To: Otago Regional Council  
Attention: Andrew MacLennan

From: Paul Morgan  
River and Fish Engineering  
Solutions

Date: 20 January 2026

The following Memo is a response to this information and issues of concern still remaining with what is proposed.

From 2024 Fish Passage Guidelines

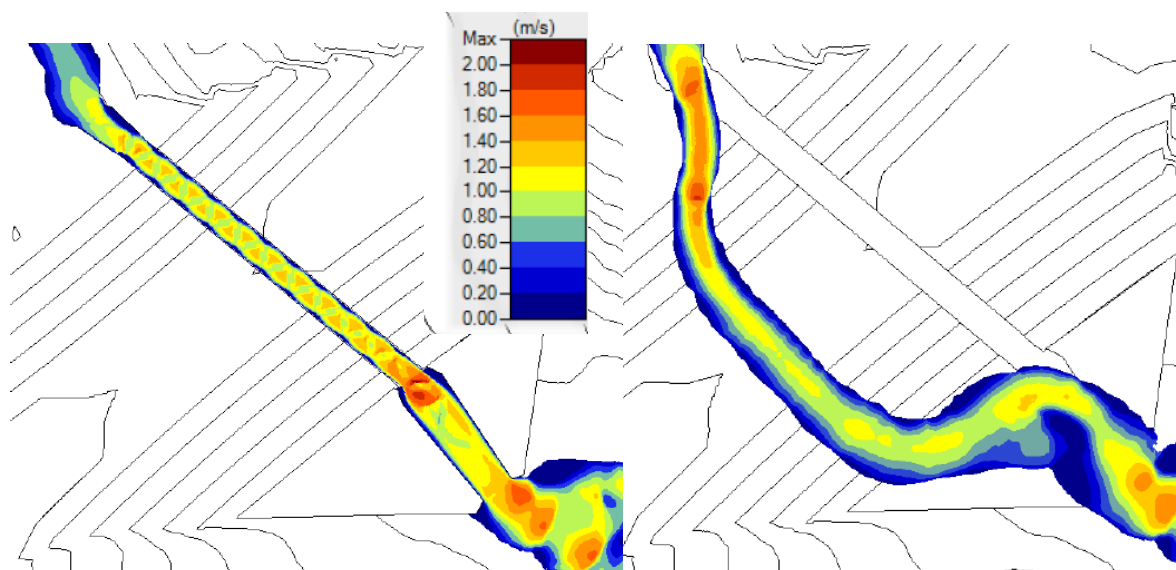
A key issue is that for small fish the sustained swimming speeds are likely to be only in the order 0.1 to 0.3m/s. The two Tables below are from the 2018 (Appendix F) and 2024 (Table 4-1) Fish Passage guidelines which show the sustained swimming speeds for several native fish and also the relationship between culvert length and what velocity of flow. Although Eldon's Galaxias are not specifically included in general swimming speeds relate to length for swimming fish and it would be expected the fish present will be within the range of fish lengths shown in this Table of 40 to 120mm (maximum length reported (NIWA) is 150mm but more common up to 110mm). The average velocity within the natural stream is likely to be greater than this velocity for most conditions and therefore highlights that it is the variation in velocity that occurs, along with areas that fish can rest that enables fish to move upstream so the culvert needs to not only be consistent with the average velocity of the stream but also provide for that variation. In practice it is usually not possible within a culvert to provide the same variability in velocity and therefore a lower average velocity than the stream at least for low to moderate flow conditions is a potential approach to help address that issue.

Part of Figure 18 (left) design with culvert and Figure 19 (right) the existing stream.

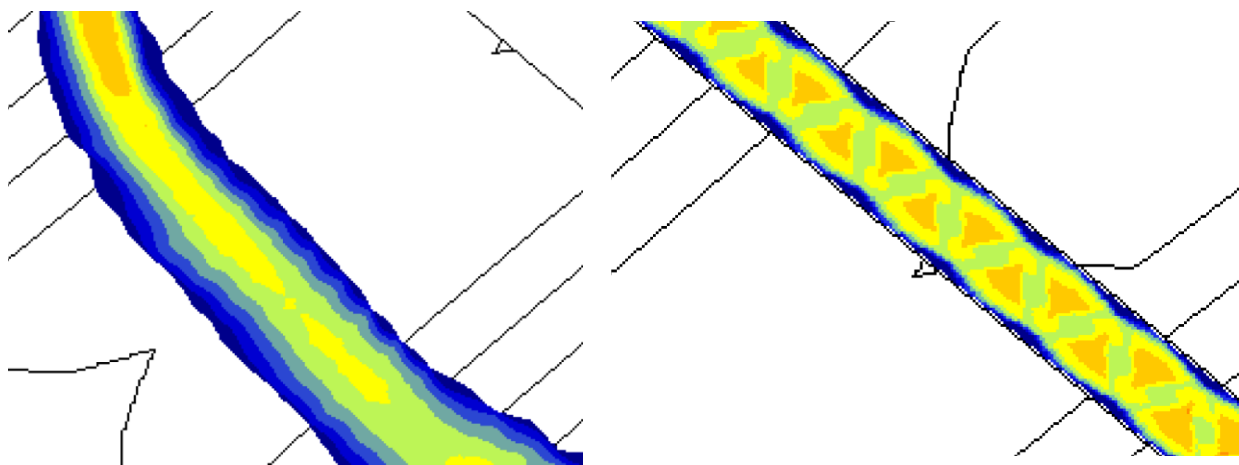
These figures highlight some of the concerns with the effect of the proposed culvert for the velocity profiles from the hydraulic modelling results. The results show that the margin where there are much lower velocities (darker blue colours) is a lot larger in the natural channel in comparison to the culvert where it is only right against the vertical sides. These results are indicated as being for high flow design condition, but it is expected that the general patterns shown will be the same for low flow conditions just with a reduction in overall velocity.

The velocities in the culvert show that the proposed “meandering low flow channel” has all velocities above 0.8m/s, whereas the natural channel has continuous pathways of flow down to 0.2m/s. In this example there is flow that extends across the whole width of the culvert but in lower flow conditions the flow will remain within this channel which although meandering in plan view has a very similar profile along the length. The culvert is 35m long, but this channel appears to be in the order of 50% longer so

in that condition is making the length in the order of 50m long for fish to travel that follow that low flow channel. There are no resting areas or areas of low velocity in that condition for the fish to rest in. The velocity profiles above show that the complex velocity environment in the natural channel is not present in the culvert.

The modelling of the velocity is a good indication of what the velocities are, but it is important to note that this is a 2d model and therefore does not account for the vertical variations that occur within a channel. For a culvert this variation will not be significant as there is consistency in shape and no other objects impacting velocity. The hard vertical edge of a culvert is a significant limitation for higher flows whereas in a stream that has sloping sides means even at higher flows there will be a band of much lower velocity on the edges. In a natural channel there is variation in bed and general channel profile, rocks and other effects on the velocity including vegetation. So, the issues highlighted above show a lack of variation in flow patterns if they were modelled in 3d would expect an even larger difference between the natural channel and the culvert. In 3d there would be much more variability in the edges of the natural stream than what is being shown especially in lower flow conditions. This is what creates the ability for small fish to swim upstream utilising low velocity areas and areas to rest between the need for burst speed needs in some sections.

This means that the complex and variable flow velocity condition that occurs in the stream is not accounted for in the culvert and based on the swimming speeds for fish it seems unlikely that fish will be able to successfully swim upstream through the culvert.

Figure 4-9: Swimming speeds and endurance for inanga. Quantile regression was used to establish relationships between swimming speed and endurance for different percentages of individuals. Adapted from Crawford et al. (In review).

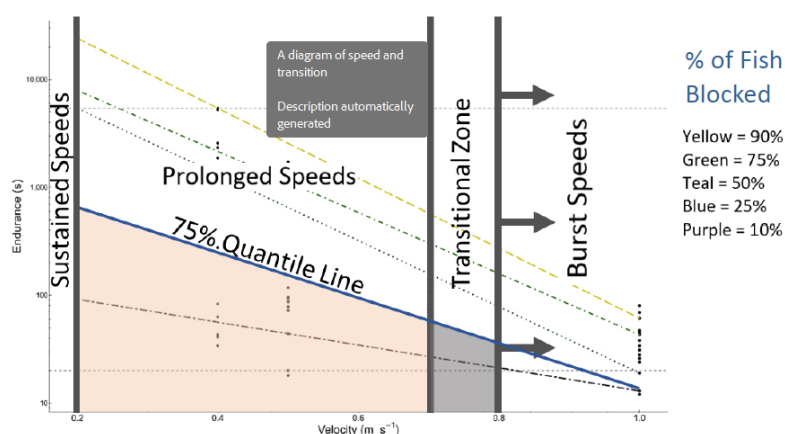
In the Fish Passage Guidelines 2024 there is a methodology show to compare the calculated velocity within the culvert with fish swimming speeds. Figure 4-9 from the Guideline (seen below) provides for a methodology to account for swimming speeds sustainable for a given time. This comparison does not appear to have been undertaken for the design flows for both high and low conditions and therefore the analysis is incomplete.
